**Lehigh Southwest Cement Company**

April 15, 2010

**Subject:** Re: NOTICE OF VIOLATION and required corrective action for failure to protect stormwater at industrial facility

**Facility:** Lehigh Southwest Cement Co. (formerly Hanson Permanente Cement)  
Industrial facility, located at 24001 Stevens Creek Boulevard, Cupertino,  
Santa Clara County  
WDID No. 2 4310062677

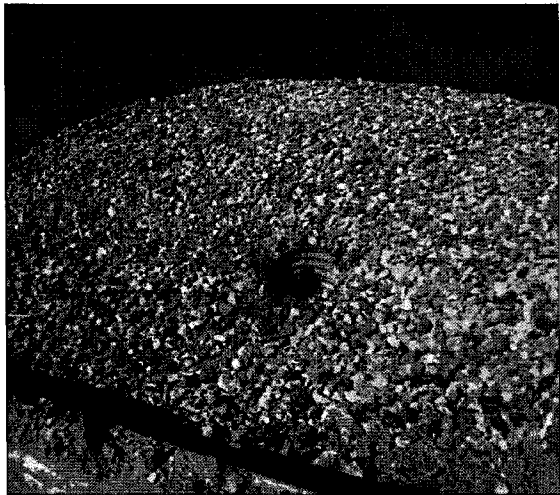
**4. INSPECTION FINDINGS:** The EPA Contract Inspector observed, during the inspection, that the Pond 9 BMP was not adequately inspected and maintained to prevent the discharge of sediment from the upgradient sediment generating sources in Drainage Area D to Permanente Creek. Table 6-1 of SWPPP 14 shows that the contributing area for Pond 9 is Drainage Area D, which includes the Rock Plant Road.

Sediment accumulation was present at the southwestern inlet to Pond 9, and sediment was being actively conveyed from the Rock Plant Road to the southwestern inlet to Pond 9 (see attached Photographs 20 and 21). Sediment-laden water was present in Pond 9, and erosion was observed at the northeastern inlet which lacked flow dissipation BMPs (see attached Photograph 22). As specified in Figure 2 of SWPPP 14, the Pond 9 outlet is connected to an outfall to

The Environmental Manager explained that maintenance of Pond 9 had been restricted by regulatory agency actions in the past, but maintenance of Pond 9 was re-instituted in 2007. As a result of the sediment accumulation and sediment-laden water present in Pond 9, there was a potential for the discharge of sediment to Permanente Creek. BMPs must be adequately inspected and maintained to reduce sediment conveyance to the pond from the sediment generating sources in Drainage Area D, and prevent the subsequent discharge of sediment to Permanente Creek.

**Lehigh Response:** Pond 9 receives stormwater that come into contact with aggregate customer bulk trucks and plant mobile equipment. The pond is designed to retain this storm water allowing potential sediment to dropout before moving to the discharge standpipe. Additionally, the pond structures a limestone material around the discharge standpipe for further sediment control and water "polishing" prior to discharge. The recent frequency and intensity of the storms in late January / early February 2010 resulted in the inlet of Pond 9, only one of the five roadway inlets, to be filled with sediment. Pond 9 was inspected late in January and, at that time, was holding up well. At the time of the inspection the pond still retained retention capacity to allow for sediment dropout. However, it was noted that the limestone filter material had fallen away during the most recent storms prior to the February 10<sup>th</sup>, 2010 inspection.

Because of contractor scheduling delays and storm events the scheduled Pond 9 clean out will be carried out the week of April 19, 2010.

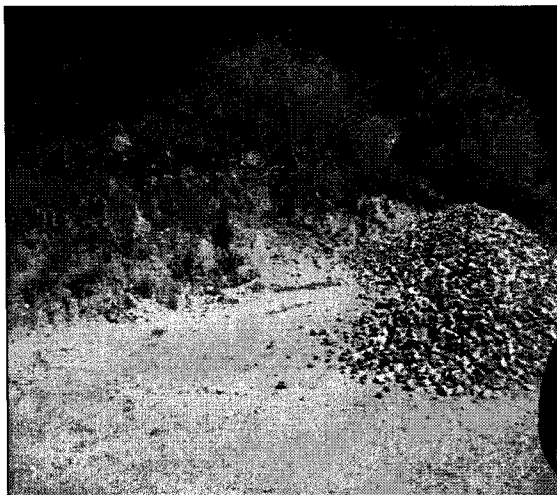
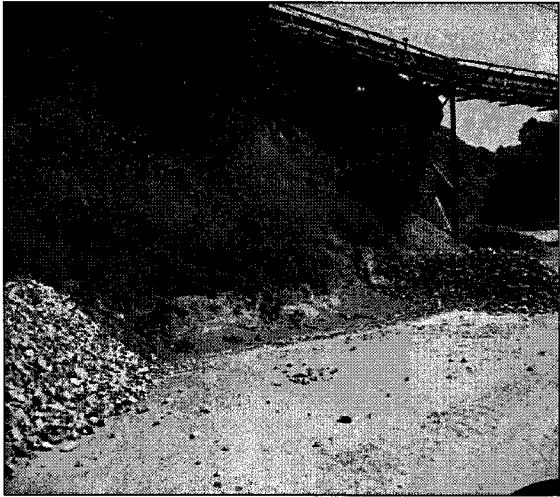
**5. INSPECTION FINDINGS:** The EPA Contract Inspector observed, during the inspection, that BMPs were not adequately inspected and maintained to prevent the discharge of sediment from a series of sediment traps located along Rock Plant Road. Table 6-1 and Figure 3 of SWPPP 14 shows that this portion of the Rock Plant Road is located in Drainage Area D, which drains to Pond 9.

Evidence of slope erosion was observed at an area known as the Rock Pile, including gully formation on the Rock Pile slope (see attached Photograph 26). Sediment accumulation in the sediment trap at the base of the Rock Pile was nearing the capacity of the BMP (see attached Photograph 27). Subsequent down-gradient sediment traps along Rock Plant Road were also nearing capacity due to sediment accumulation (see attached Photographs 28 and 29). Sediment-laden flow was observed bypassing the sediment trap BMPs and flowing down the roadway (see attached Photograph 29), potentially contributing to the sediment loading in Pond 9 (as described in Finding 4, above).

The Environmental Manager indicated that the Permittee does not have a structured schedule for inspection and maintenance of structural BMPs such as Pond 9 and the sediment traps. Because the sediment trap BMPs and Pond 9 had not been adequately inspected and maintained, there was a potential for the discharge of sediment beyond Pond 9 to Permanente Creek. BMPs must be adequately selected, installed, inspected, and maintained to reduce sediment conveyance to the pond from the sediment generating sources in Drainage Area D, and prevent the subsequent discharge of sediment to Permanente Creek.

**Lehigh Response:** The unpaved road referenced in the inspector's report, Lower Quarry Plant Road, has a series of catchment bays, or sediment traps, on the inclined portion side on the road.

These “trap” bays have been very successful in capturing sediment-laden stormwater along this area. The inspector noted that the “trap” bays had not been maintained. The fact is that these traps are cleaned out and re-established during the dry season. During the wet season, these bays are cleaned out in between storm events, when water has subsided to the extent that cleanout activities do not subject the area to “mud” drainage and / or spillage. The recent frequency and intensity of the storms in late January / early February 2010 did not allow for cleaning of these bays prior to the February 10, 2010 inspection. However, these bays were cleaned out of material on February 17, 2010, when the weather’s “break in the rain” had allowed for a minimal of mud disturbance. The bays are currently functional. It should be noted that the discharge from these bays go Pond 9 for further clarification / sediment fallout prior to discharge.

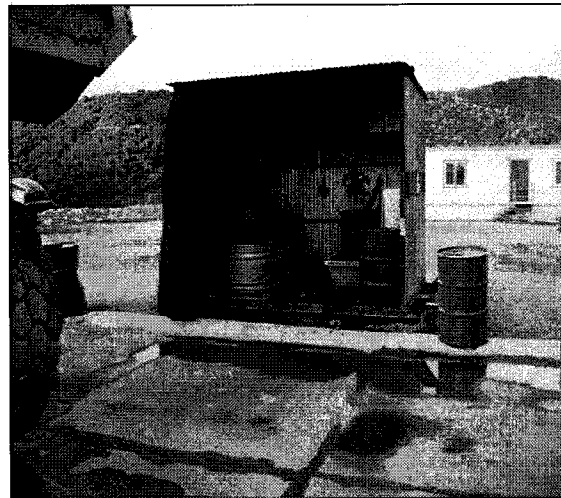
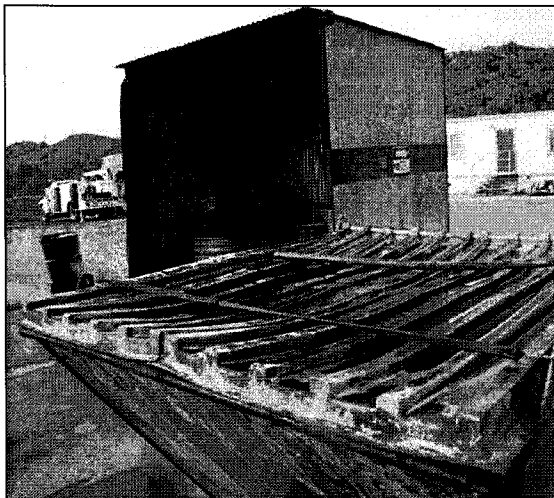
**10. INSPECTION FINDINGS:** The EPA Contract Inspector observed, during the inspection, that adequate Material Handling and Storage BMPs were not implemented to minimize exposure of significant materials to storm water at the heavy equipment maintenance pad located east of the active quarry pit near the Quarry Office (see attached Photograph 49). In an e-mail dated February 24, 2010, The Environmental Manager stated that "the SOP to keep the area free of oily residue will allow for water to be discharged after inspection for oil sheen or other contaminants...water will be filtered prior to discharge" (see attached Exhibits 1 and 2). However, standing water was present on the concrete maintenance pad and the pad was nearing capacity (see attached Photographs 49 and 55). Standing water has the potential to increase storm water contact with pollutants, particularly after maintenance activities occurring on the concrete pad.

Full drums of petroleum-based automotive lubricants were stored in standing water at the concrete pad (see attached Photographs 50 through 52). In addition, an open waste container used for hazardous wastes (e.g., oil soaked rags, etc.) had accumulated standing water inside (see attached Photographs 53 and 54). As a result of these material storage practices and the standing water near the capacity of the concrete pad (see attached Photographs 49 and 55), there was a potential for the contribution of pollutants to storm water and the subsequent release of pollutants from the concrete pad.

**Lehigh Response:** This area noted is the Upper Garage, located by the Quarry Office. The poured concrete pad is equipped with curbed sides to contain rainwater. The area is used for off-road mobile equipped maintenance and repair activities. The size of the equipment maintained makes the utilization of a covered roof unrealistic. The BMP implemented is to immediately contain, isolate and clean up any spilled lubrications or other contaminants that fall within the containment area. Additionally, all maintenance work in the containment area is limited during a storm event.

The petroleum based lubricants have been moved to a covered container stored outside of the noted containment area. The lubricant drums are stored in secondary containment within this container. Additionally, the noted waste container for oily rags has the covers affixed and in the closed position, and has been equipped with bungee cords to maintain cover closure. See photos below; note that the peripheral empty and clean blue barrels are utilized to cover ground level bolts, protecting mobile equipment tires from potential damage.

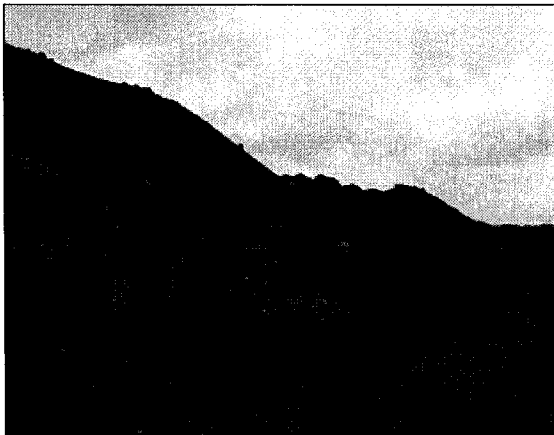
**11. INSPECTION FINDINGS:** The EPA Contract Inspector observed, during the inspection, that adequate BMPs were not implemented to prevent the discharge of sediment from the unstabilized Upper Quarry Road, roadway shoulder, and associated cut and fill slopes located approximately 0.5 miles southeast of the West Material Storage Area (see attached Photograph 56).

The slope near the intersection of Upper Quarry Road and an access road leading northeast, showed erosion, including gully formation (see attached Photographs 56 and 57), fine sediment accumulation at the toe of the slope (see attached Photograph 58), and slope failure (see attached Photograph 59).

In addition, flow dissipation BMPs had not been implemented in the roadway drainage ditches, and erosive flow was observed running down the surface of Upper Quarry Road without proper grade to direct flows into the drainage ditches (see attached Photographs 60 through 62). As a

result, there was a potential for the discharge of sediment to the active Quarry Pit. Furthermore, the unstabilized Upper Quarry Road, roadway shoulder, and associated cut and fill slopes are a potential source of the elevated total suspended solids results (47,200 mg/L) at the SL-6-RD sample location on January 18, 2010. Adequate BMPs must be implemented to prevent the discharge of sediment from the unstabilized Upper Quarry Road, roadway shoulder, and associated cut and fill slopes to the active Quarry Pit.

**Lehigh Response:** The inspector was notified that what he described as the fine sediment accumulation was actually a fine mud material by-product from the washed aggregate system of the "Rock Plant". This mud, which accounts for approximately 15% of the aggregate plant total throughput, is stored in the overburden Material Storage Areas (designated as West (WMSA) and East (EMSA) in Lehigh's SWPPP). When the inspector wanted to look at one of the terraced roads in the WMSA, the truck literally got stuck in the mud. The water content of this mud is such that it forms a cohesive paste product that, even during rain events, does not allow for sediment movement. Erosion noted by the inspector directly above the mud storage area is not a significant source of sediment and is contained within this storage area.

It should be noted that the upper WMSA Road is inner cut (slanted or banked) into the hill side, so water flows via a natural curb on the hill side of the road. All of this water is eventually diverted to the quarry bottom for accumulation, retention and settling. This water is pumped out of the quarry bottom to a secondary retention pond, then to pond 4a for further retention and material settling before discharged to Permanente Creek. The quarry bottom pumping operation is controlled by turbidity meters that cease operation if the turbidity rises above 30 NTU.

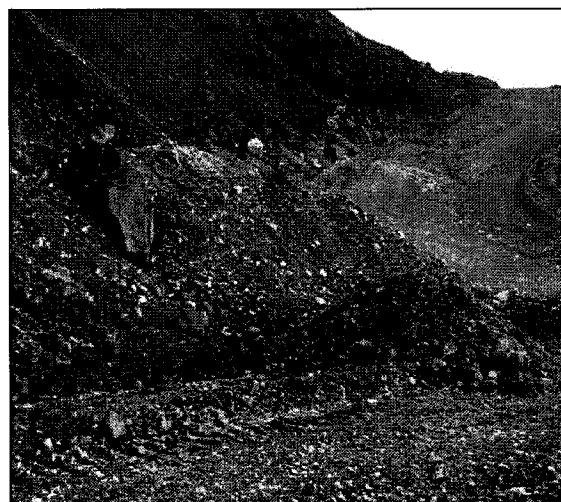
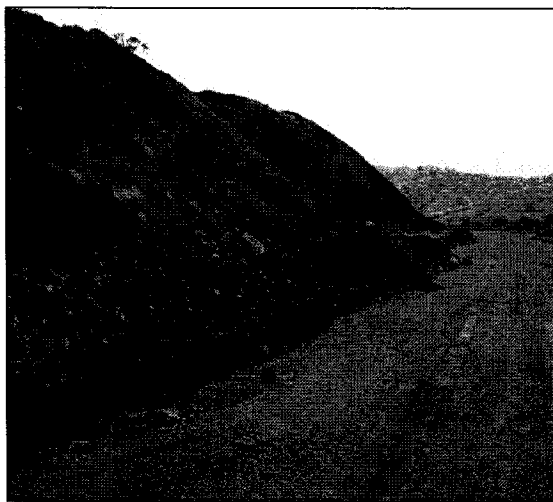
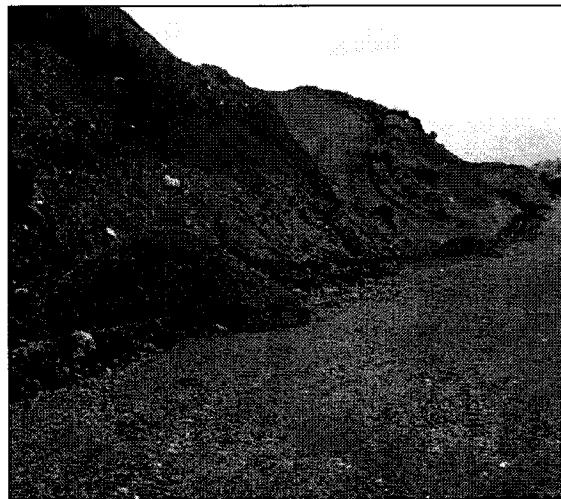
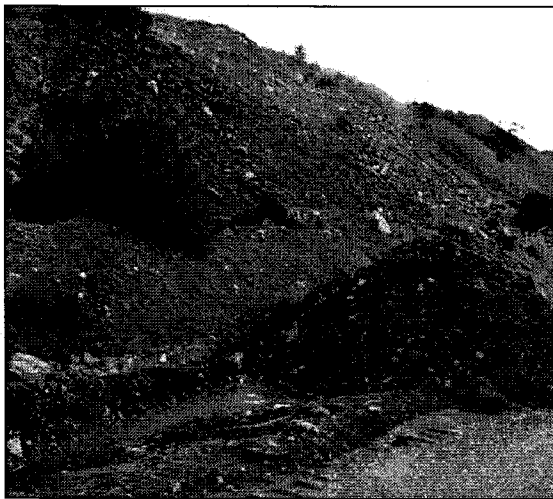
The inspector made the recommendation of utilizing sediment bays, or traps similar to those use at the lower quarry road, to help hold potential sediment from being carried via storm event water to the quarry bottom. The sediment sources in the WMSA would be the disturbed areas of the roads and material storage areas. Lehigh has implemented the inspector's recommendation by installing 28 sediment traps along the upper WMSA roadway, and further curbing the road's hill side incline. See photos below:

It should be noted that, even before installation of the additional BMPs, none of the items of concern at the WMSA roads, operations or storm event BMPs had any potential impacts/discharge effects to Permanente Creek because they drain into the quarry retention pond, where settling occurs prior to pumping into Pond 4, where further settling occurs and from there these waters are discharged into Permanente Creek. As described herein, the BMPs are functioning effectively. Accordingly, Lehigh takes issue with the characterization of this the BMPs as a violation resulting from an improperly installed and maintained road. The existing BMPs are protecting Permanente Creek water quality from potential impacts of sediment; nevertheless, as stated Lehigh has added the recommended BMPs as additional measures...
